CCK-2695-23 ADDENDUM # 1 2/16/2023

CENTER FOR ROBOTICS AND MANUFACTURING SYSTEMS

MODIFY ROOMS R9, R112 AND R112C FOR NEW EQUIPMENT

UNIVERSITY OF KENTUCKY LEXINGTON, KENTUCKY

A-111

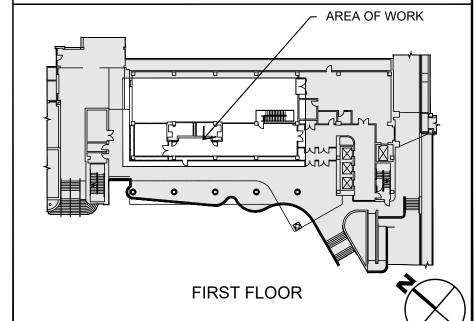
DELEGATED DESIGN: ENGAGE A QUALIFIED PROFESSIONAL ENGINEER TO DESIGN STRAINS, LANDINGS, AND RAILINGS, INCLUDING ATTACHMENT TO BUILDING CONSTRUCTION.

- A. STRUCTURAL PERFORMANCE OF STAIRS: METAL OR FRP STAIRS SHALL WITHSTAND THE EFFECTS OF GRAVITY LOADS AND THE FOLLOWING LOADS AND STRESSES WITHIN LIMITS AND UNDER CONDITIONS INDICATED:

- 1. UNIFORM LOAD: 100 LBF/SF.
 - 2. CONCENTRATED LOAD: 300 LBF APPLIED ON AN AREA OF 4 SQ IN.
 - 3. UNIFORM AND CONCENTRATED LOADS NEED NOT BE ASSUMED TO ACT CONCURRENTLY.

- 4. STAIR FRAMING: CAPABLE OF WITHSTANDING STRESSES RESULTING FROM RAILING LOADS IN ADDITION TO LOADS SPECIFIED ABOVE.
 - 5. LIMIT DEFLECTION OF TREADS, PLATFORMS, AND FRAMING MEMBERS TO L/360 OR 1/4 INCH, WHICHEVER IS LESS.

- B. STRUCTURAL PERFORMANCE OF RAILINGS: RAILINGS SHALL WITHSTAND THE EFFECT OF GRAVITY LOADS AND THE FOLLOWING LOADS AND STRESSES WITHIN LIMITS AND UNDER CONDITIONS INDICATED:

- 1. HANDRAILS AND TOP RAILS OF GUARDS:
 - a. UNIFORM LOAD OF 50 LBF/FT APPLIED IN ANY DIRECTION
 - b. CONCENTRATED LOAD OF 200 LBF APPLIED IN ANY DIRECTION.

- c. UNIFORM AND CONCENTRATED LOADS NEED NOT BE ASSUMED TO ACT CONCURRENTLY.

- 1. PATCH AND REPAIR FLOOR AS NEEDED.
- 2. STRIP, POLISH, AND SEAL CONCRETE FLOORS.
- 3. [ALTERNATE 1] PROVIDE AND INSTALL NEW DOOR AND FRAME. SEE A-002 FOR ADDITIONAL INFORMATION. MATCH EXISTING STOREFRONT DOORS.
- 4. [ALTERNATE 1] PROVIDE AND INSTALL SHOP FABRICATED METAL OR FRP STAIRS, HANDRAILS AND GUARDRAILS. ANCHOR AND DESIGN TO MEET ALL APPLICABLE CODES AND REQUIREMENTS.

HEIGHT FROM TOP STAIRS DECK TO FLOOR IS 16'-10±. FIELD
 - HEIGHT FROM TOP STAIRS DECK TO FLOOR IS 16'-10±. FIELD VERIFY HEIGHT BEFORE FABRICATION.
- 5. MODIFY AS NECESSARY TO AVOID EXISTING UTILITIES.
